Re: Hearst Elementary School
DCRA Building Permit Tracking Number B1501123
Zoning Reviewer Comments

Hearst Elementary Building CD
3950 37th Street NW, Washington DC
Building Permit # B1501123

RMc response to the DCRA Zoning comments dated June 16, 2015 via phone conversation with Mr. David Vollin. The following are the comments and design team response;

A200

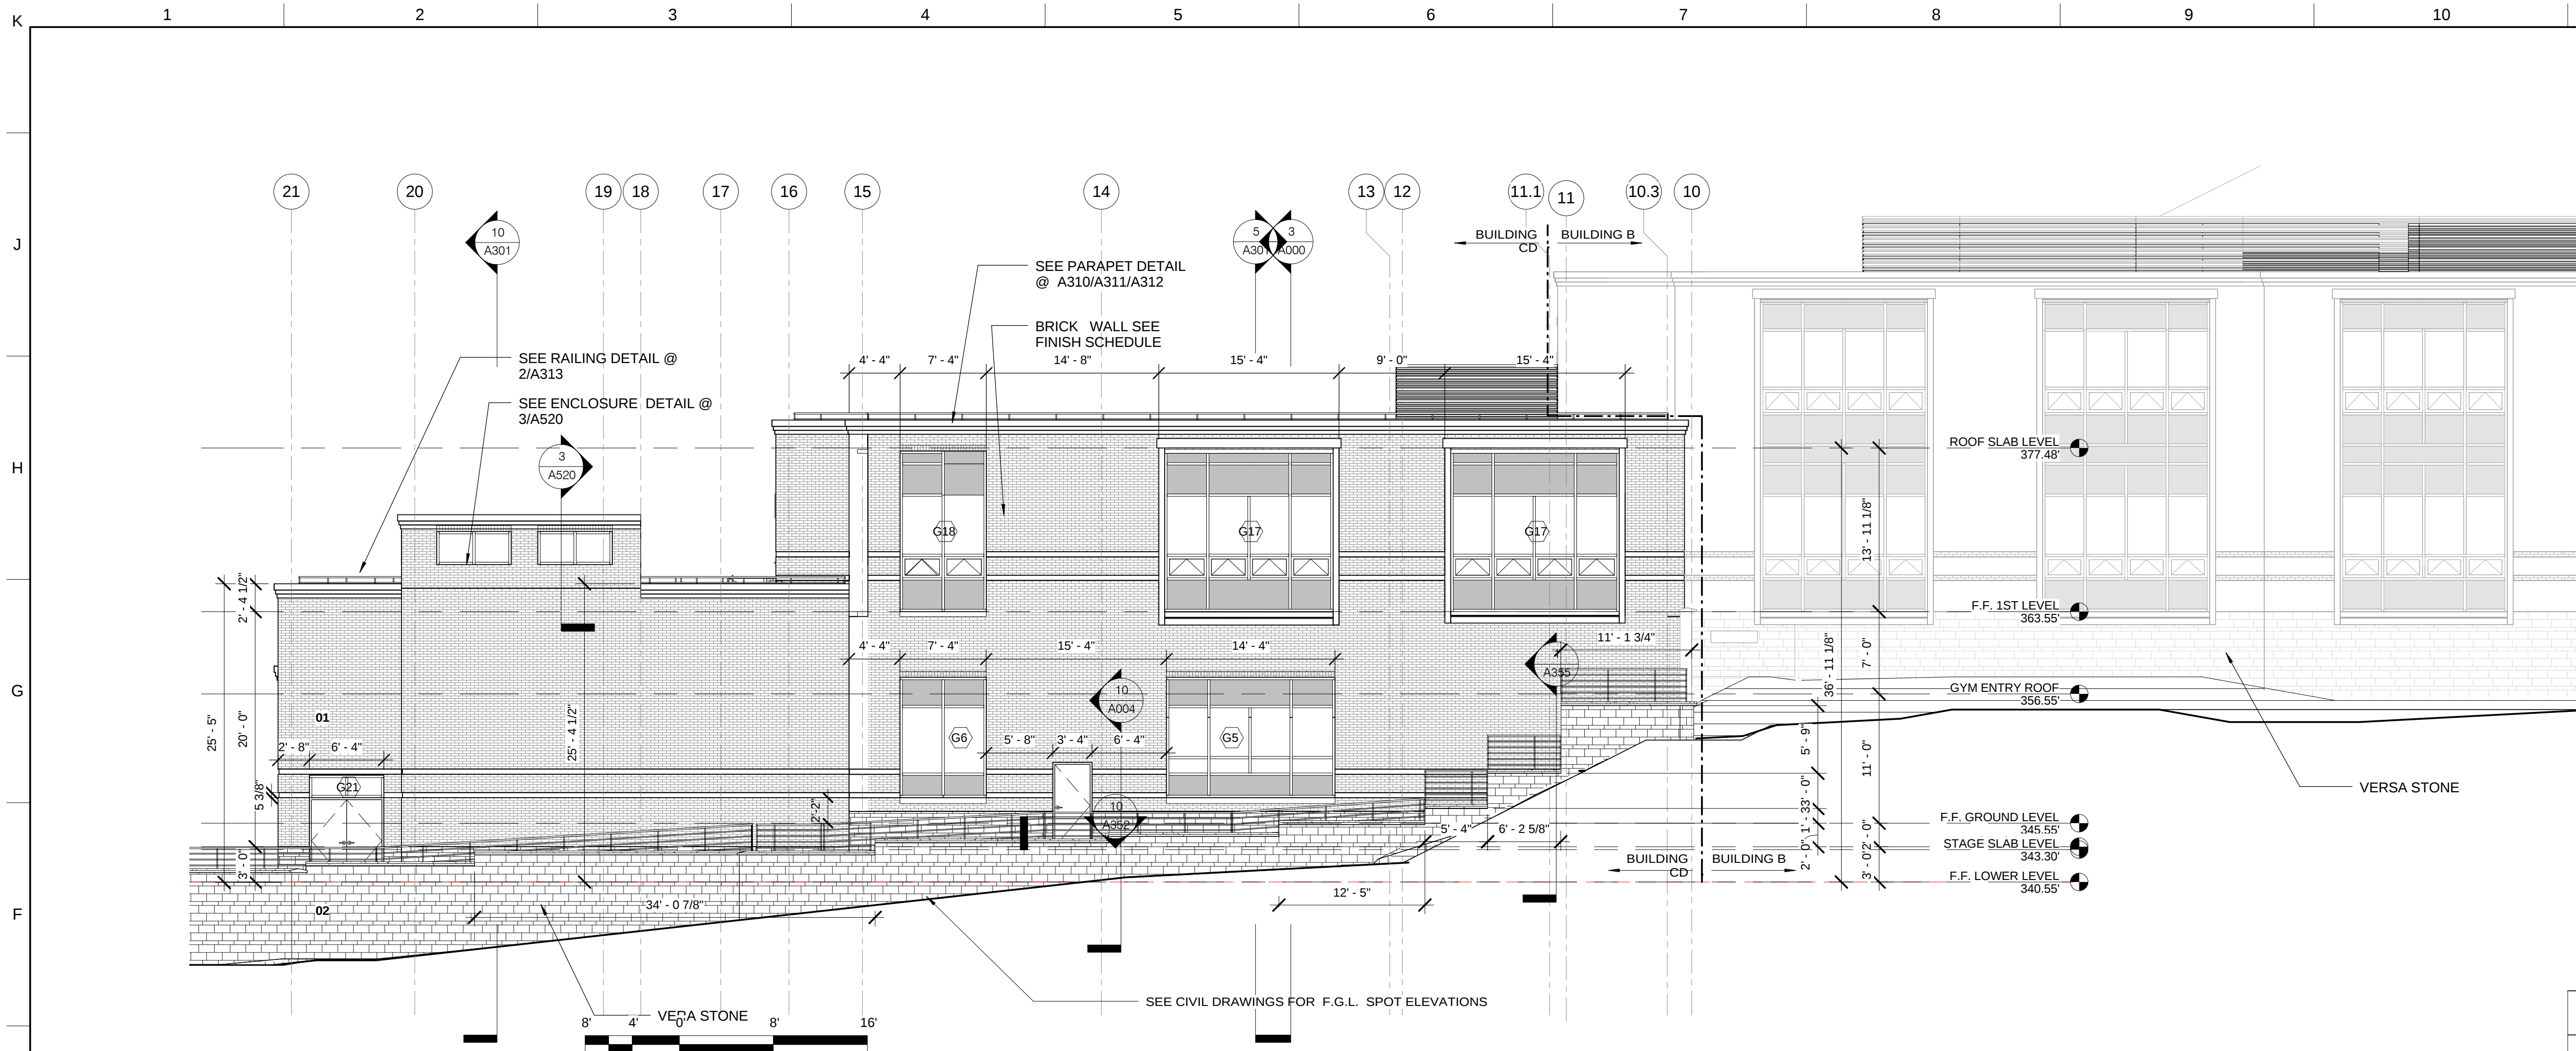
- 1. All required screening and mechanical equipment shall have a 1 to 1 setback from all exterior walls or BZA is required**

After waiting for few months, we received comments via phone call from Mr. David Vollin, Tuesday, June 16, 2015, regarding the 1:1 ratio. According to Mr. Vollin, the parapet we showed in our drawings shows extension only in the area of the mechanical equipment where it requires a 1:1 setback from the exterior wall, and still not compliance apparently the parapet needs to be extended to the perimeter of the roof structure, whereby increasing the length and height of the whole parapet above the roof level.

PER DCRA ZONING COMMENTS

In response to the DCRA comment listed above, sent by Quinten L. Washington, dated February 11, 2015, Design team responded to the comment dated 3/17/15 with updated drawings, based on our interpretation of the zoning regulation 411 and 770.6, to show drawing revisions in the mechanical screen at the North East corner of the building which is the subject of the comments. See attached A104, A200, and A201.
